Manuscript: Restoration Analysis: Lake Michigan-Huron Water Levels

Author(s): IUGLS Study Team

Name of Reviewer: R. A. Halliday, P. Eng.

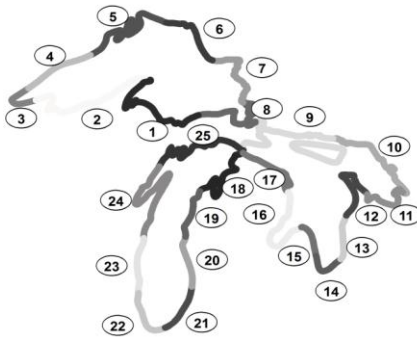
4.3.3.1 – Paragraph 3, re description of SAT. Do the 25 shoreline segments encompass the entire shoreline of the two lakes, or are they simply a sample? (Figure 4-13 implies a sample.) If they are a sample, what is the sampling methodology?

The 25 shoreline segments encompass the entire shoreline of the two lakes. Figure 4-13 (reproduced below) shows that the shoreline segments cover the entire shore of each of the two lakes (Superior and Michigan-Huron). As stated in the text, however, while estimates of the number and length of existing shore protection structures were available throughout the 25 zones shown (plus wave characteristics at these sites), more detailed information on the nature and characteristics of the structures were available in only three reaches: Racine County, Wisconsin; Lake and Cook Counties, Illinois; and the Collingwood-Wasaga Beach area of Ontario. Therefore, the structural characteristics from these three reaches provided a sample for the remaining sections, and this was used to establish the model.
